Davis-Besse Nuclear Power Station
Docket No. 50-346, License No. NPF-3

Response to Requests for Additional Information Related to Alternative Dissimilar Metal
Weld Repair Methods (TAC Nos. ME0477 and ME0478)

Response to 10/8/09 Request for Additional Information Related to Requests RR-A32 and
RR-A33, Alternative Dissimilar Metal Weld Repair Methods

Figure 1 Time to Failure of Alloy 182 in Primary Water as a Function of Stress

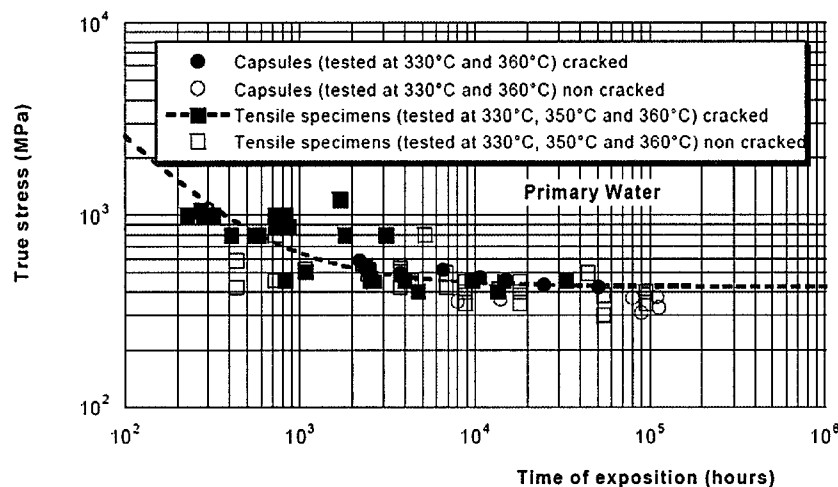
Two types of tests of PWSCC initiation in Alloy 182 weld metal, as illustrated in Figure 1, exhibited no failures at stress levels less than 58,000 psi. Based upon the data, it was concluded that Alloy 182 is susceptible to stress corrosion cracking in pressurized water reactor primary water only if the applied stress exceeds the yield stress [Reference 3].

Figure 2 Relationship between Stress and the Crack Growth Rate of PWSCC Microcracks of a Welded Specimen by Alloy 132 in 325°C (617°F)

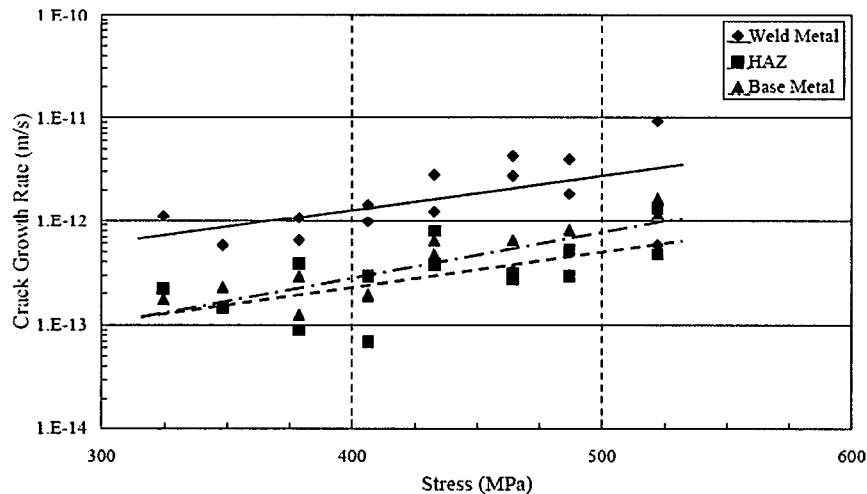
Reference 6 presents crack growth rate data for microcracks initiated in two different types of crack initiation specimens. Although reported as crack growth data, the experiments were actually crack initiation tests, since the crack growth rate was computed based on failure time divided into thickness of the thin walled specimens tested under uniform stress conditions. Samples tested at stress levels down to approximately 47,000 psi, illustrated in Figure 2, revealed crack growth rates slow enough (0.0012 inch/year) to be of little engineering significance.
